PLANNING COMMISSION

AGENDA

Monday, October 13, 2025
5:15 p.m.

Public Hearing (continuance): Planning File PD-01-25 et al Type III Quasi-Judicial Process Application for planned development of an unassigned property as a senior housing community consisting of 98 duplex units, indoor and outdoor open space with a private road system. The proposal includes consolidation of two properties into one 147.01-acre parcel, a Site Plan Review for the felling of 21 trees, a Natural Resource Impact Review for the addition to the impervious area and the removal of vegetation within the riparian corridor and grading and paving of land within the Special Flood Hazard areas.

C101

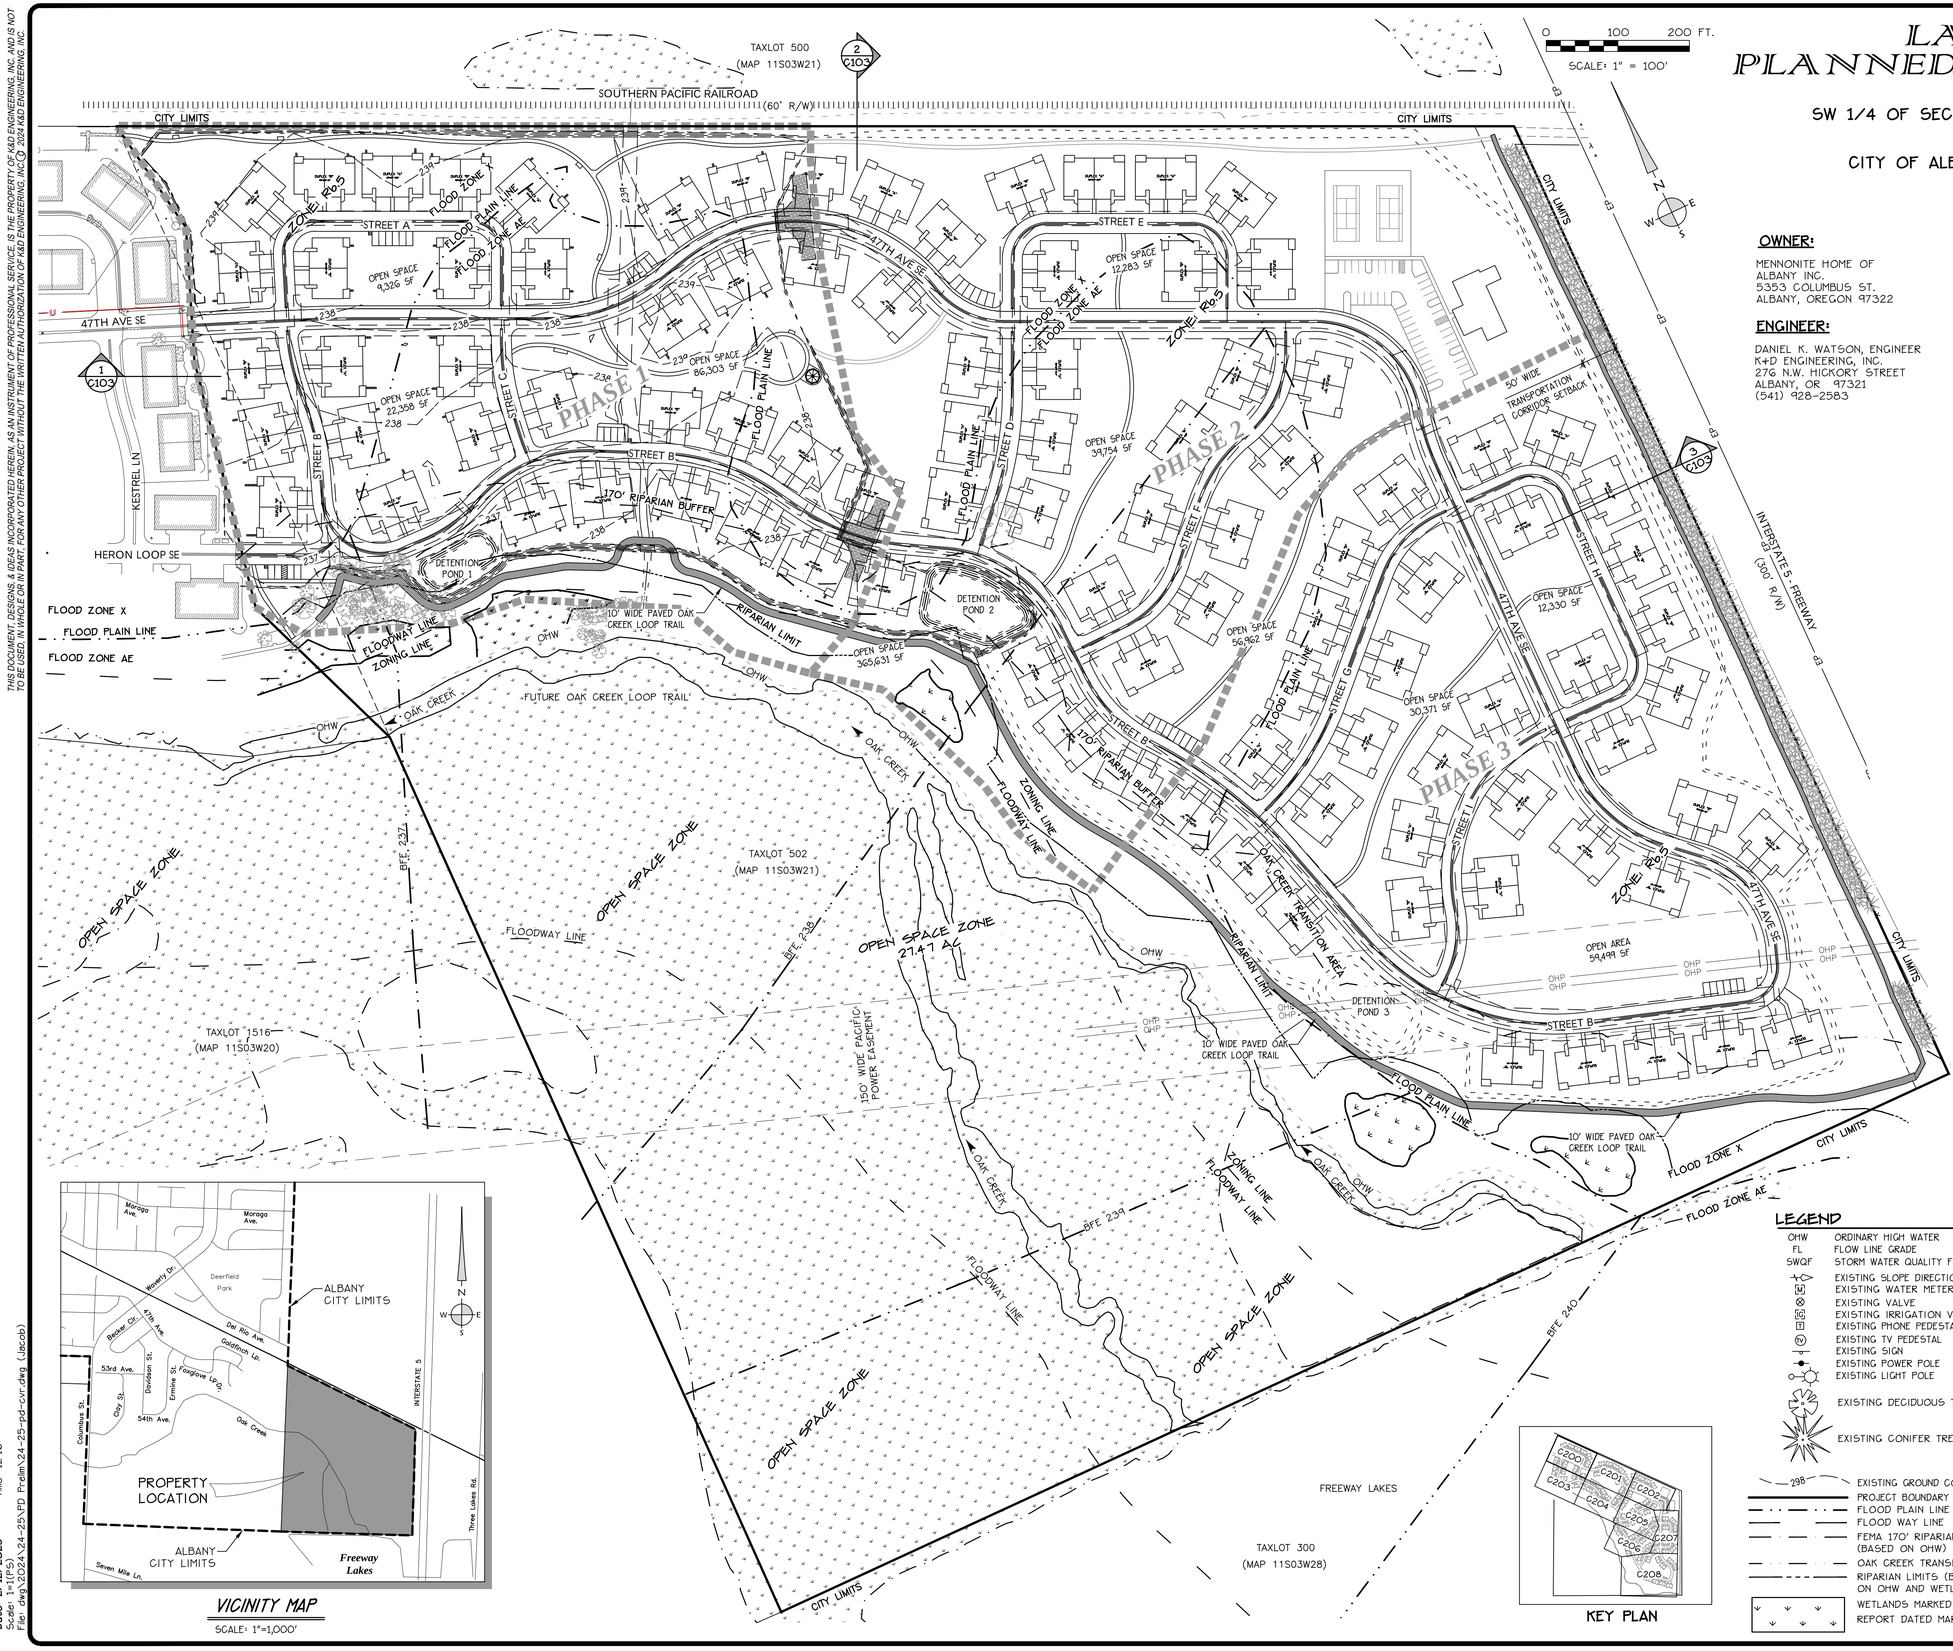
Now, 21 trees are identified to be felled, 100% of them are 8" in diameter or greater, and all the Oak trees have dimensions greater than 21" in diameter and up to 42".
(*Tree Removal Exhibit, lower left corner, Sheet C101 – Existing Conditions pg. 118).

*Attached: Enlarged for ease of reading, the Tree Removal Exhibit, insert from map Sheet C-101

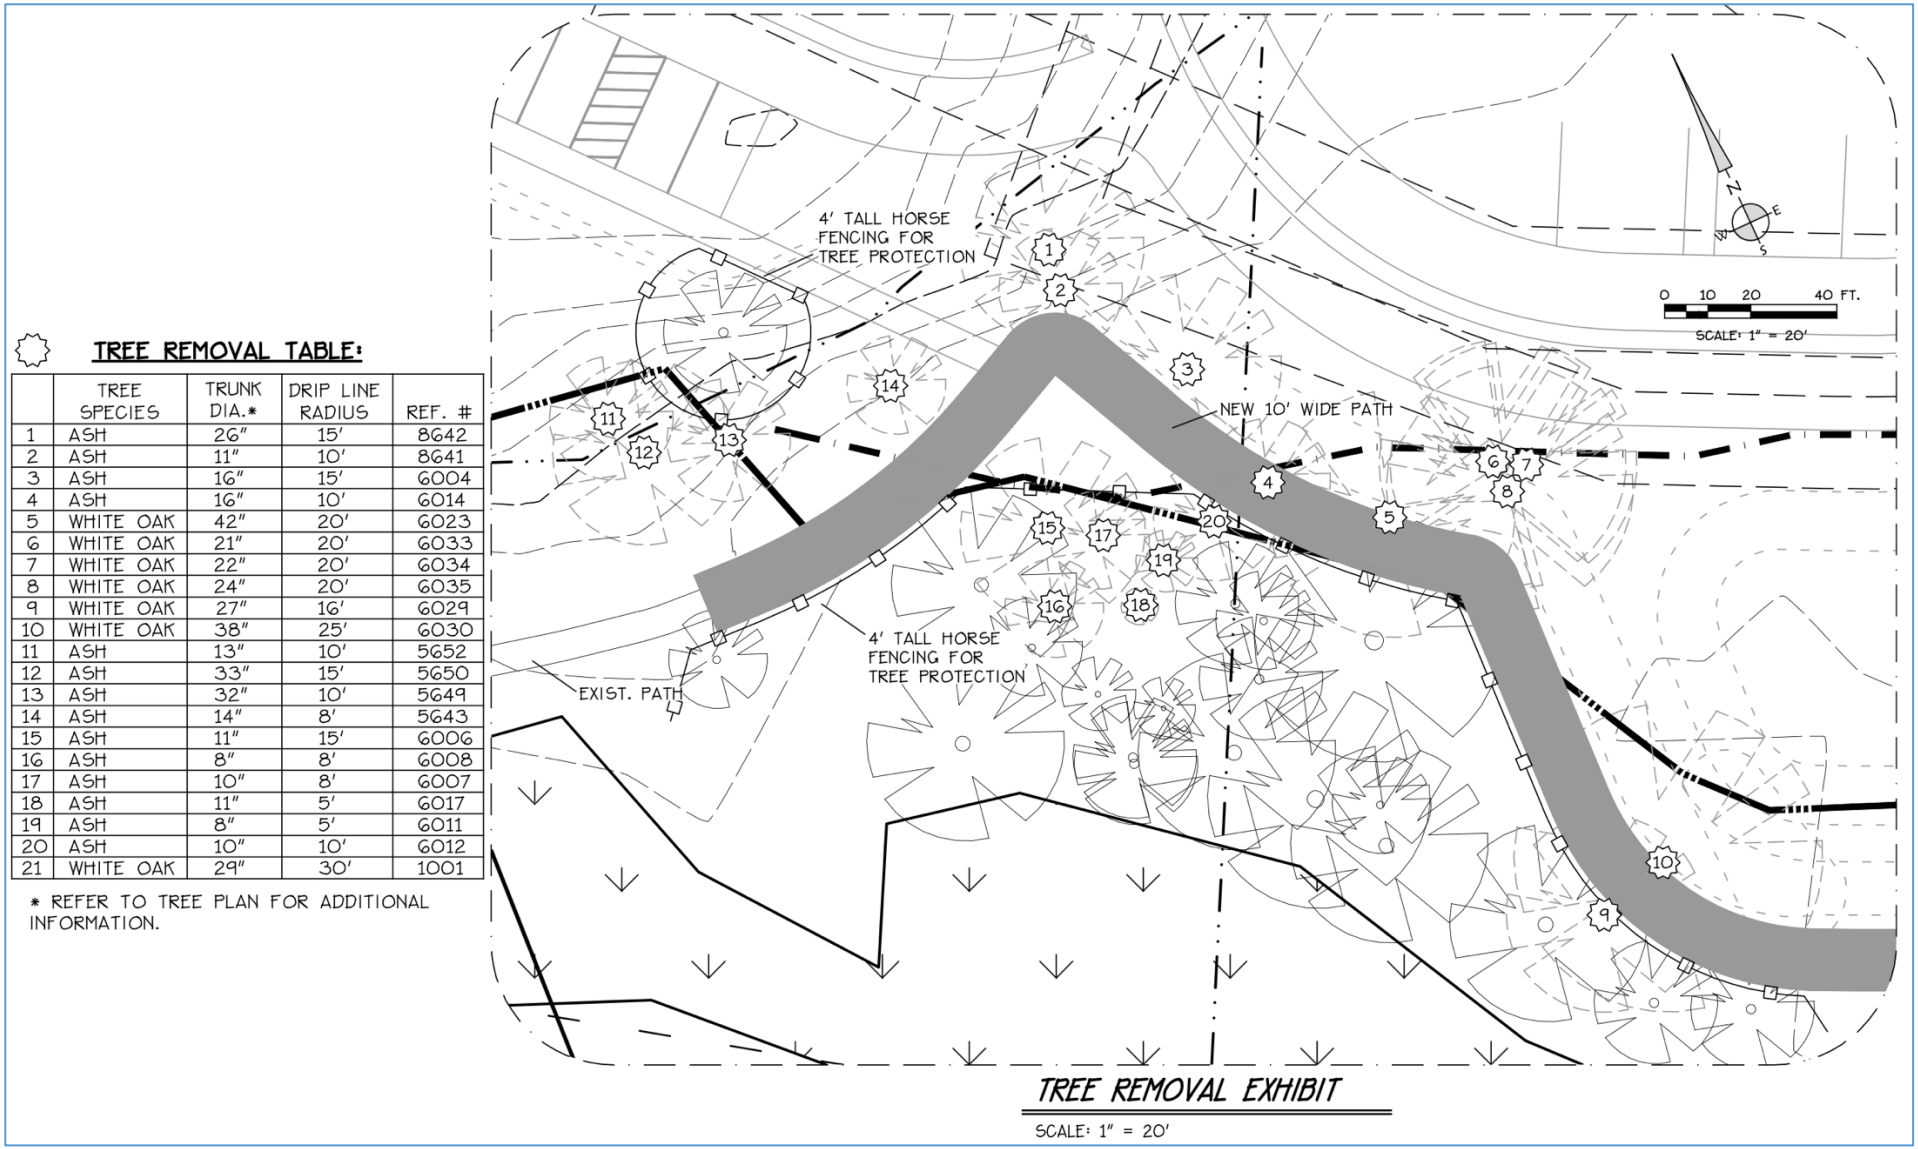
3. I ask the Commission to stipulate a Condition that the applicant involves the Village residents in planning paths and trail connectors for **Phase 1**, and Phases 2 and 3 prior to review by Parks and Recreation and Public Works and submission of the final plat.
